Stage 1 Road Safety Audit

Gort Town Centre Public Realm Scheme

On behalf of **Galway County Council**

3.3.13 Barrack Street – Controlled Crossing at R458 Junction.

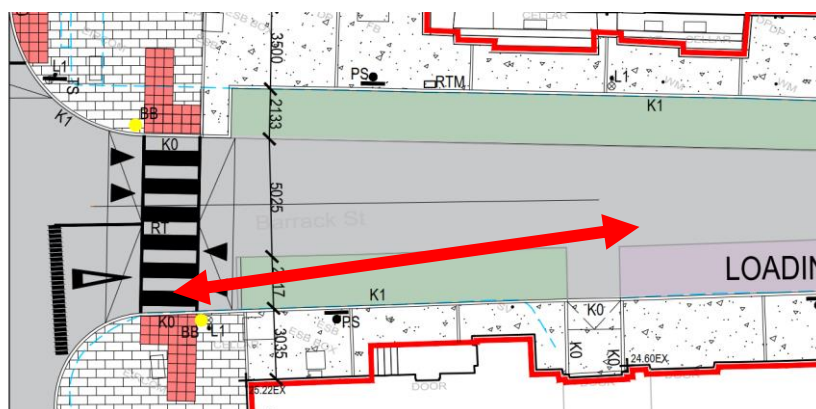
Problem: There is a parking bay located to the east of the controlled crossing. High sided vehicles within the parking bay may restrict driver visibility to the waiting or northbound crossing pedestrian.

Hazard: Pedestrians may commence their crossing unsighted to oncoming motorists.

Recommendation: The Design Team should reduce the carriageway width at the mouth of the junction such that the southern side of the crossing is visible to approaching motorists.

3.3.10	Yes	Yes		
3.3.11	Yes	Yes		
3.3.12	Yes	Yes		
3.3.13	Yes	No	Currently large vehicles reverse down Bar- rack Street. We have designed the ability for them to drive down the street and turn	No. If the carriageway width must remain, the

TO BE COMPLETED BY DESIGNER				TO BE COMPLETED BY AUDIT TEAM LEADER
Paragraph No. in Safety Audit Report	Problem accepted (Yes/No)	Recommended measure accepted (Yes/No)	Describe alternative measure(s). Give reasons for not accepting recommended measure. Only complete if recommended measure is not accepted.	Alternative measures or reasons accepted by Auditors (Yes/No)
			within the new car park. This movement requires the kerbs lines to be as shown, the swept path analysis demonstrates this. We have introduced a raised pedestrian zebra crossing to assist the ability to cross the road.	adjacent parking bay should be shortened / removed.

3.3.14 Coach Parking Near Christ the King Statue.

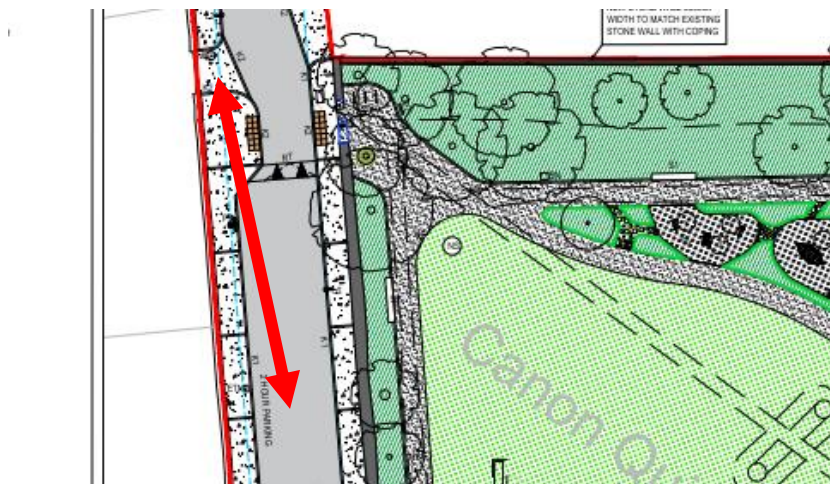
Problem: The coach parking is indicated with a K100 kerb adjacent. Some users may have difficulty in stepping from the kerb up onto the bus.

Hazard: Trip/fall incidents may result.

Recommendation: The Design Team should replace the K100 kerb with a Bus Kerb.

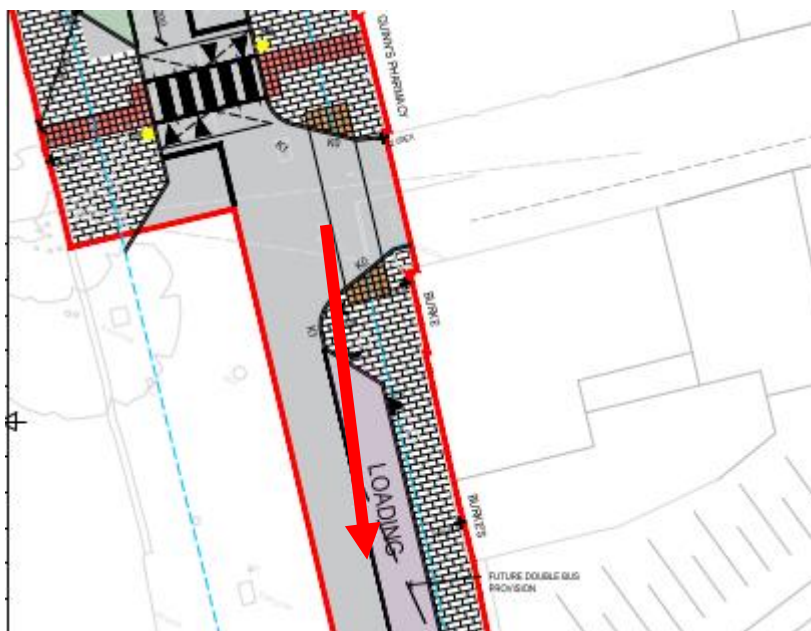
Hazard: Mobility-impaired users may fall due to the gradient.

Recommendation: The Design Team should ensure all footpath gradients comply with current best practice.

3.3.19 Station Road – Pedestrian Crossing Visibility

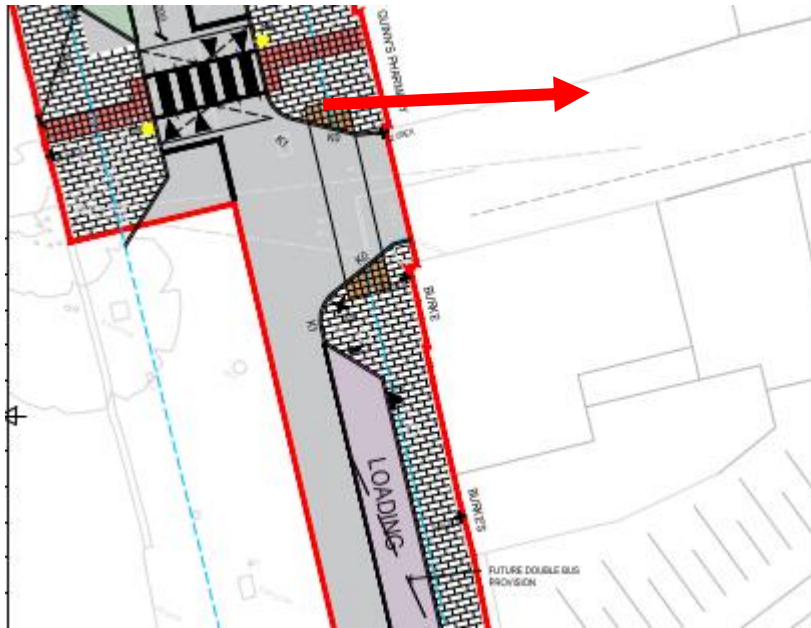
Problem: Pedestrians crossing north south of Station Road have their visibility to traffic exiting Station Road restricted by the building.

Hazard: Pedestrians may commence their road crossing and be subject to vehicle strikes.

Recommendation: The Design Team should relocate the tactile paving and dropped kerb closer to the Ennis Rd carriageway edge.

3.3.20 Gort Medical Centre – Car Park

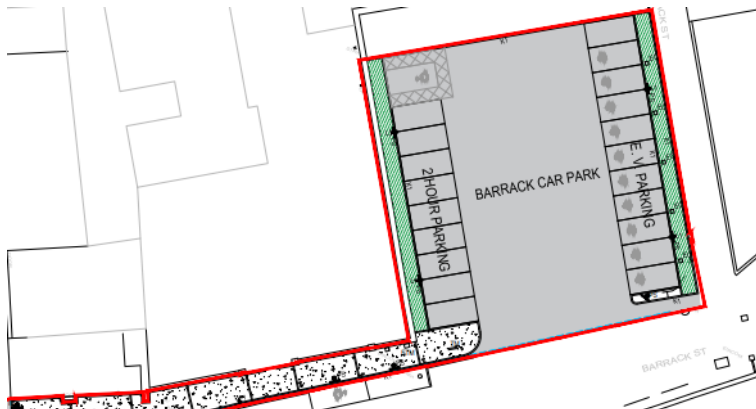
Problem: Motorists' visibility to pedestrians crossing the entrance to Gort Medical Centre is very restricted, both by boundary walls and the angle of the entrance. It was noted during the site visit this car park is very busy and has a high turnover rate.

Hazard: Pedestrian / vehicle collisions may result.

Recommendation: The team, in consultation with the medical centre, should undertake works to improve the existing car park access.

3.3.22 Barrack Street – Car Park Disabled users Parking

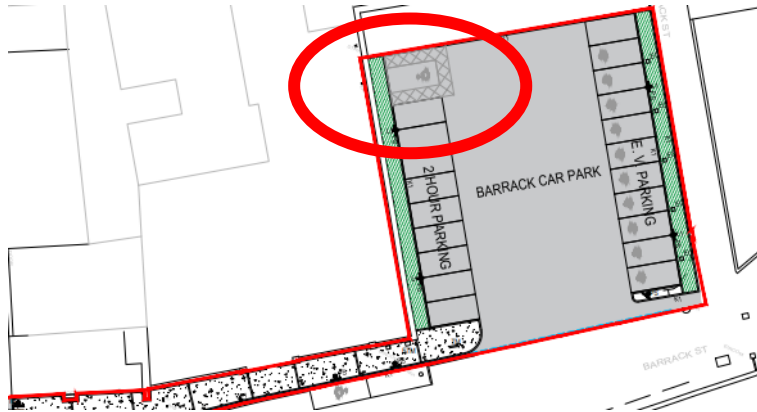
Problem: The disabled user parking space within the car park is not located adject to a segregated footpath. Disabled users will be required to walk through the trafficked area of the car park in order to access the footpath.

Hazard: Impact from passing or reversing vehicles may occur.

Recommendation: The Design Team should relocate the disabled user parking spaces, such that direct access to a segregated footpath can be achieved.
